Addendum 1 – Questions & Answers and Sign Footing Shop Drawings

**Northwest Arkansas Razorback Regional Greenway Alliance
Installation and Update of Signage
Razorback Greenway Wayfinding Signs Project**

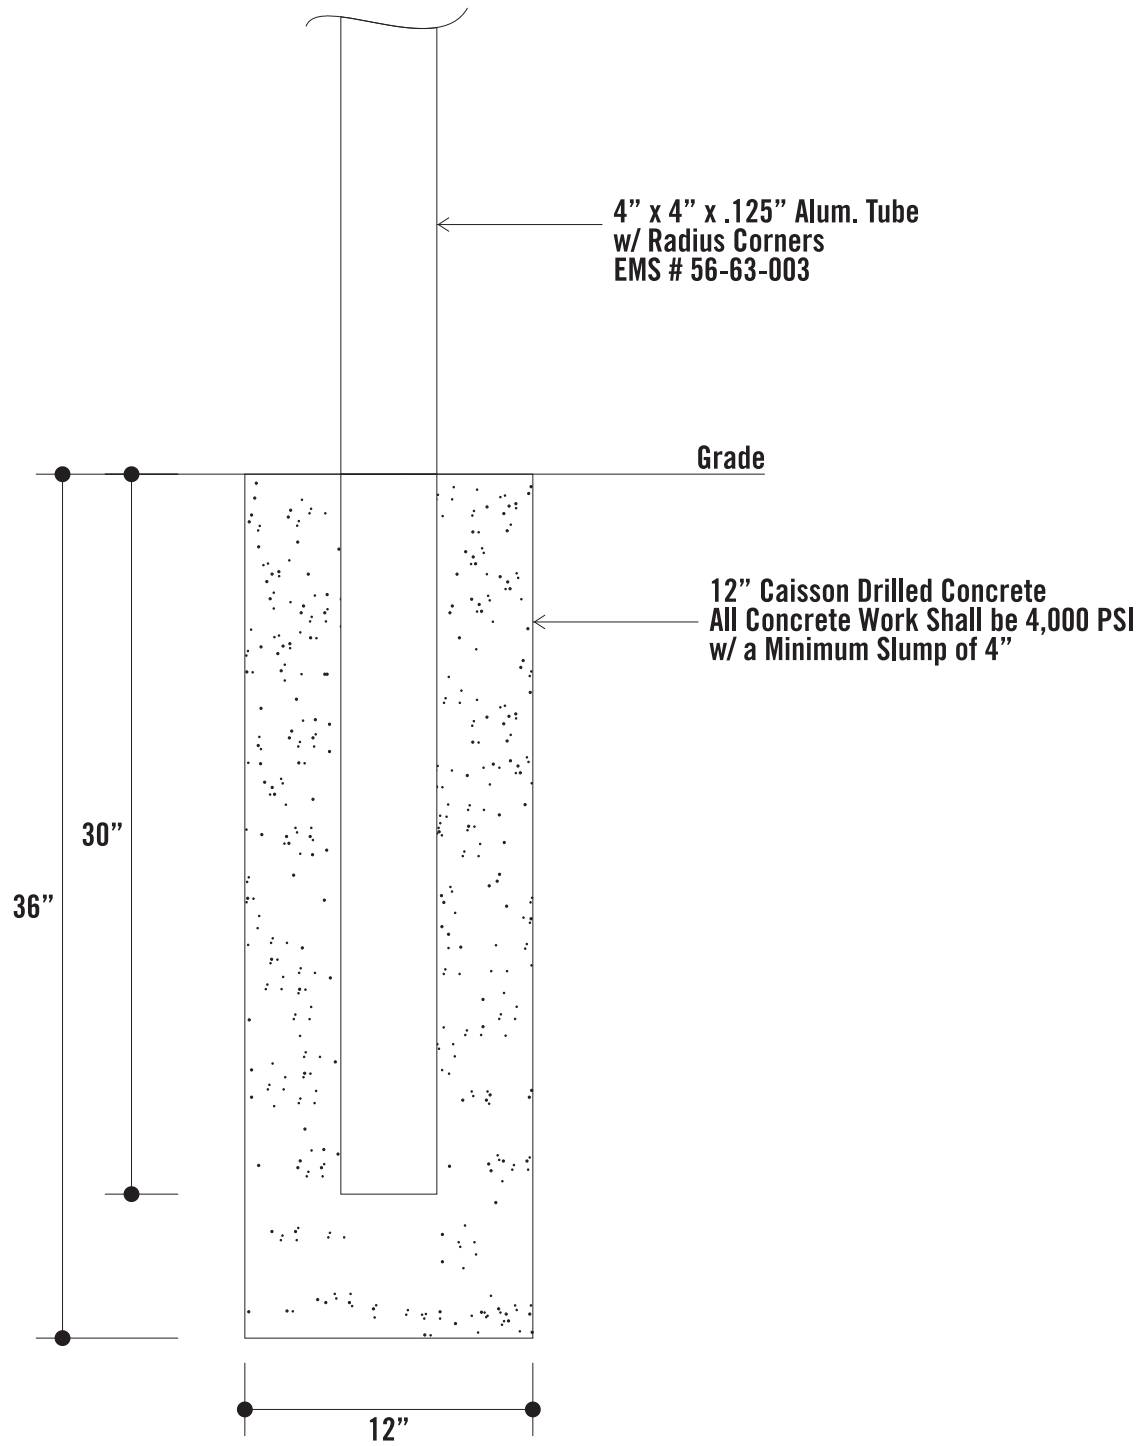
Mileage Stickers: The RFB table (p. 1) shows 600, but the Signage Package (p. 12) shows 1,078. Please confirm the correct quantity.

The correct quantities are shown on the table on page 1. The detailed drawings show details of what each sign-type should be but have incorrect quantities for this project.

LARGE INFORMATION KIOSK

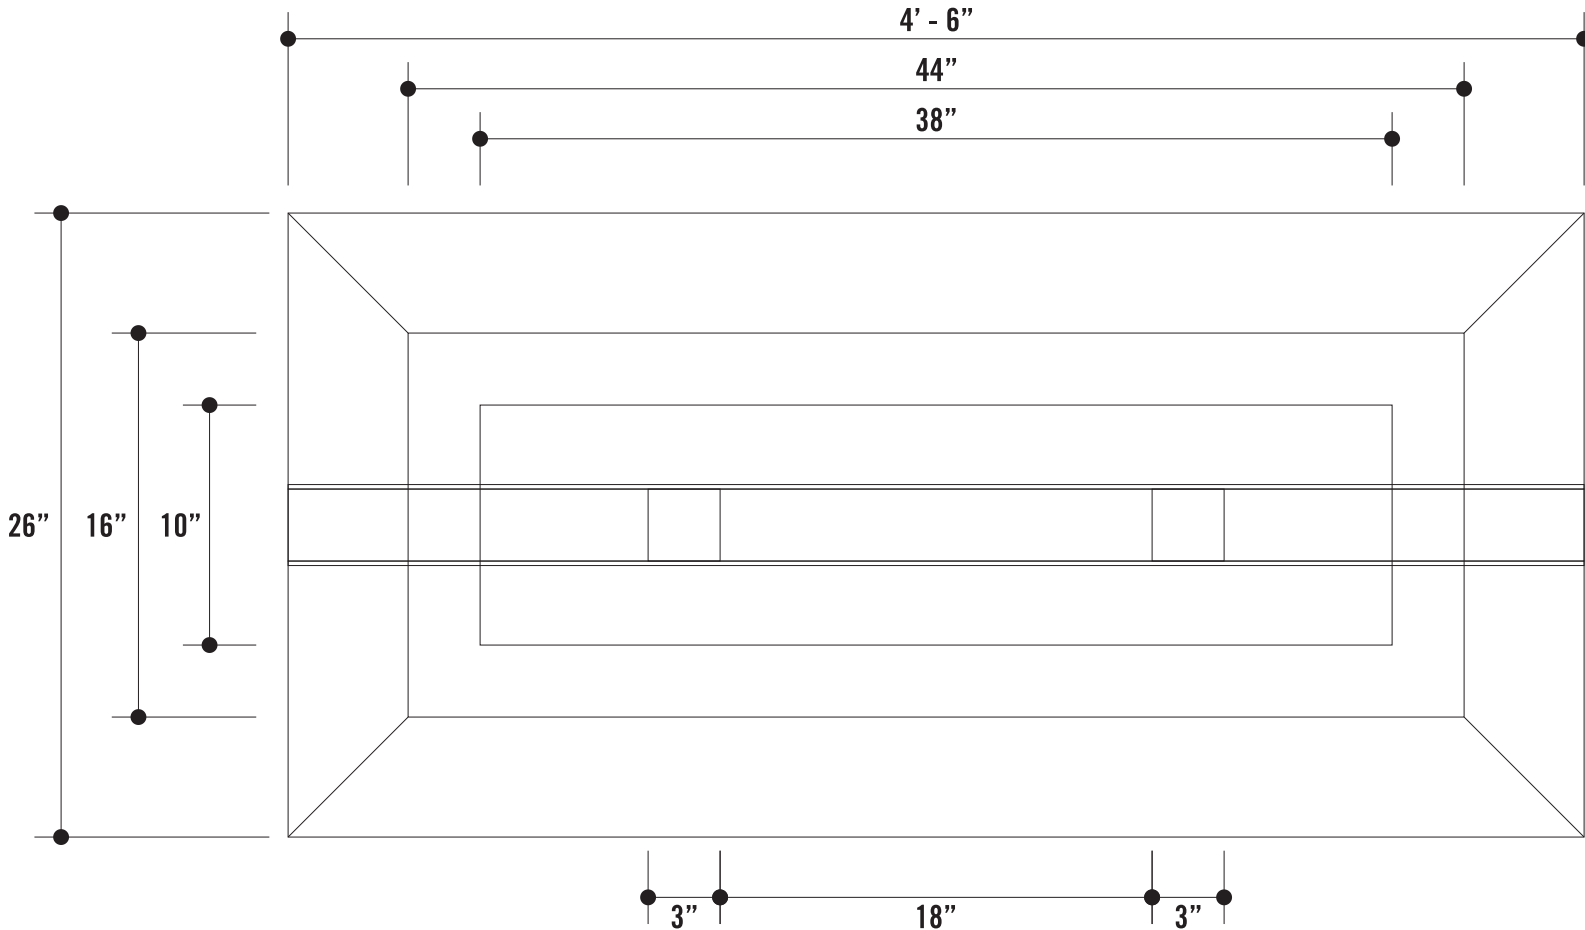
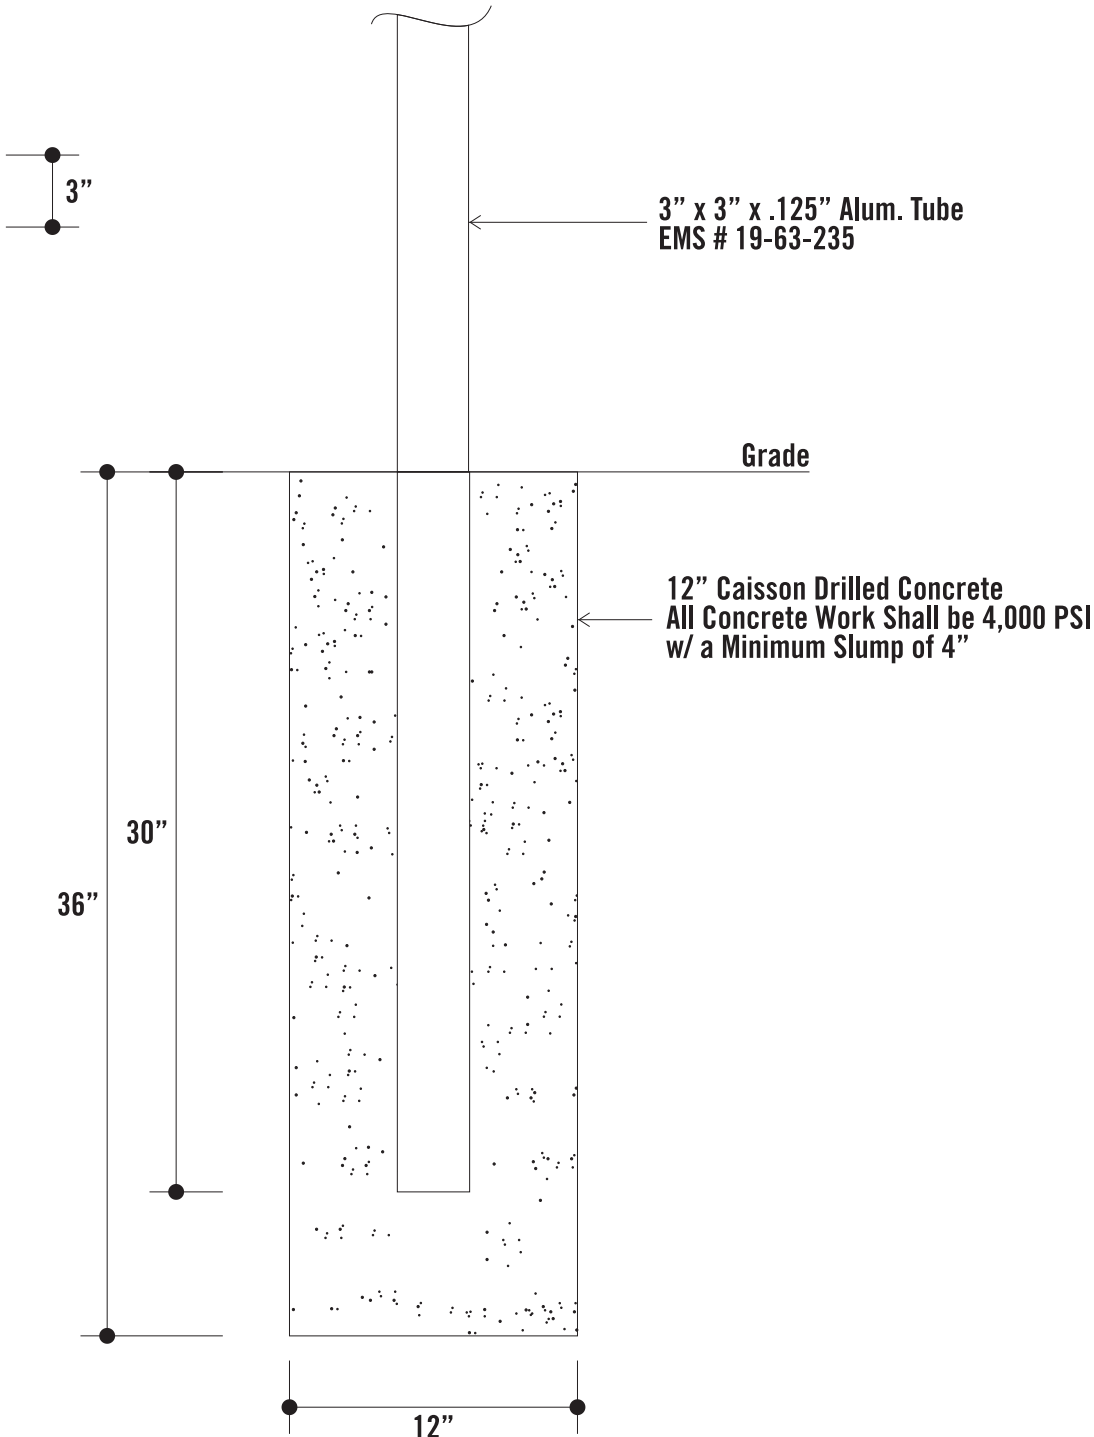
Just to confirm on the large Info Kiosk we should include with out quote the stone masonry work.

Kiosks and Area Maps: Are these completely new (footings, posts, frames, and signs), and is the 18" stone base under the Large Info Kiosk existing or new?

Yes, masonry work will be required and should be included in the quote for the Large Info Kiosk to match what is shown on page 7 of the Razorback Greenway Sign and Wayfinding Package attached to the RFB.

The kiosks and area maps will be completely new installations, including the stone base.
